CITY OF ALBUQUERQUE

RE: UNM Starbucks and Freddie's
Grading and Drainage Plan ^{MA}
Engineer's Stamp Date 1-27-2017 (File: K16D075)

Based upon the information provided in your submittal received 1-30-2017, the above referenced Grading and Drainage Plan cannot be approved for building permit until the following comments are addressed:

ENGINEER'S SEAL	STARBUCKS/FREDDY'S	DRAWN BY WCWJ
	GRADING AND DRAINAGE PLAN	DATE 12-27-17
	 1606 CENTRAL AVENUE SE SUITE 201 ALBUQUERQUE, NM 87106 (505) 872-0999	21702-LAYOUT-1-16-17
DAVID SOULE P.E. #14522		SHEET # —
		JOB # 21702

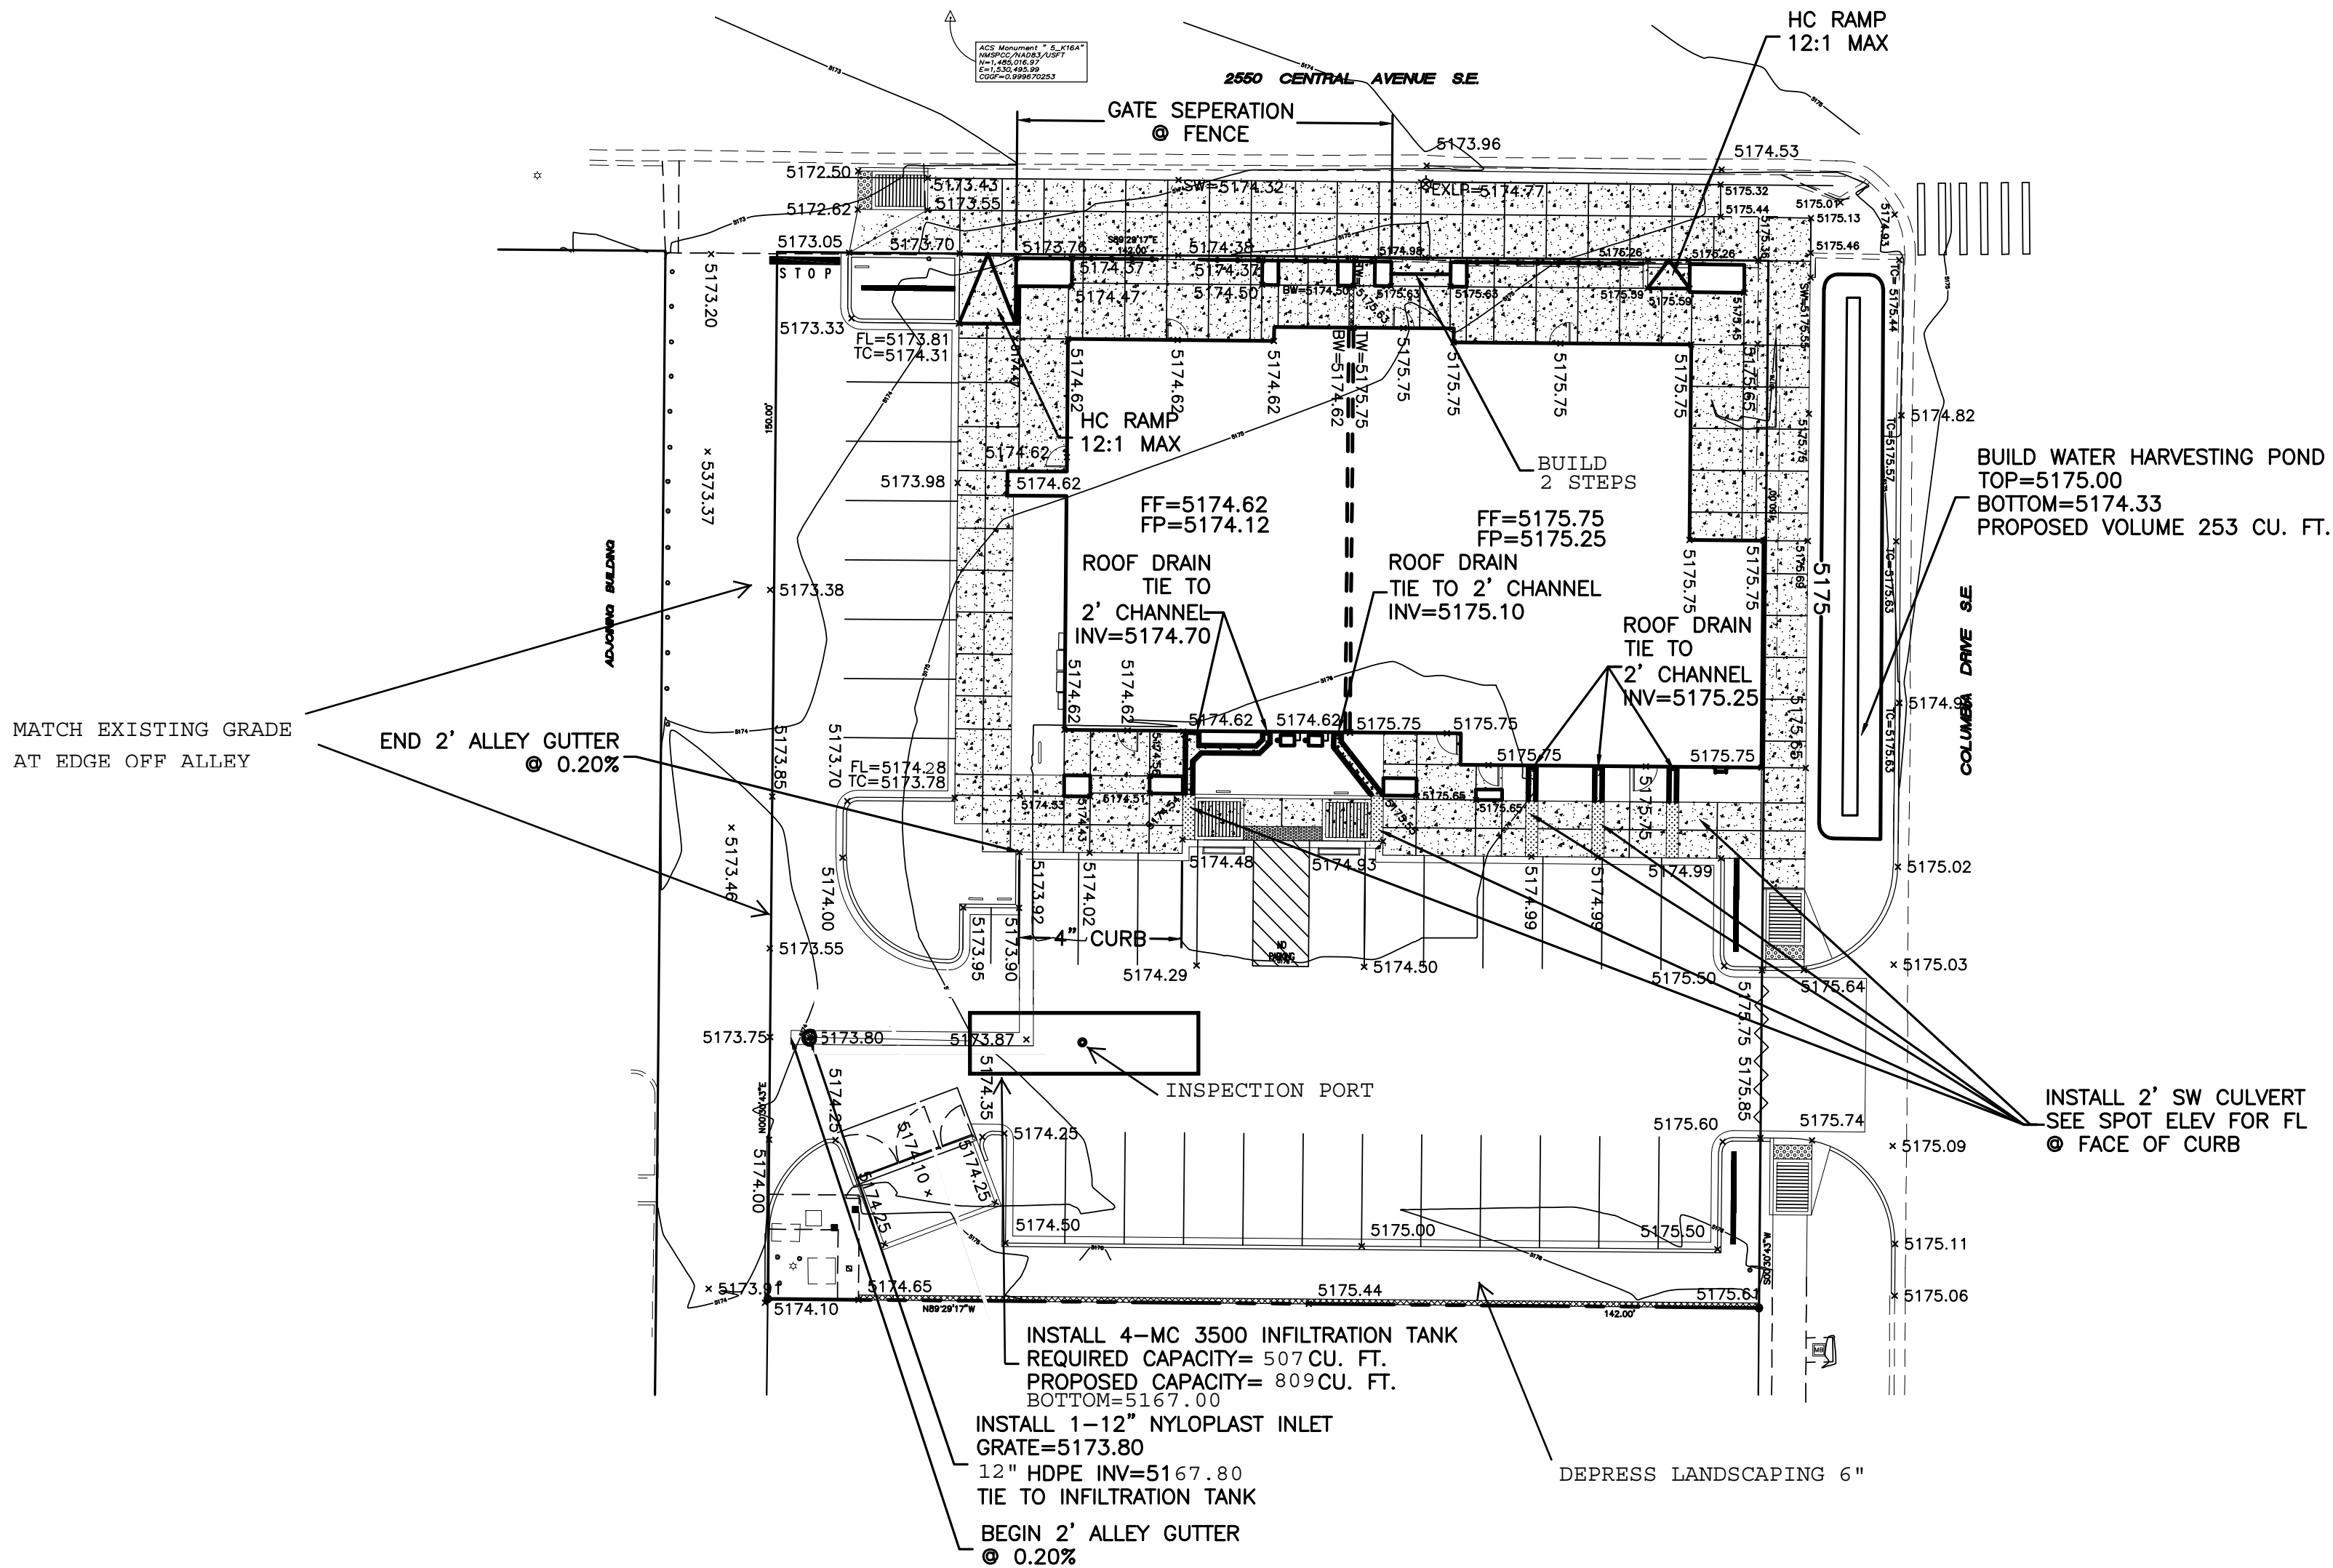
1. Provide build note and grade elevation for the dumpster.
2. Provide narrative for offsite flow.
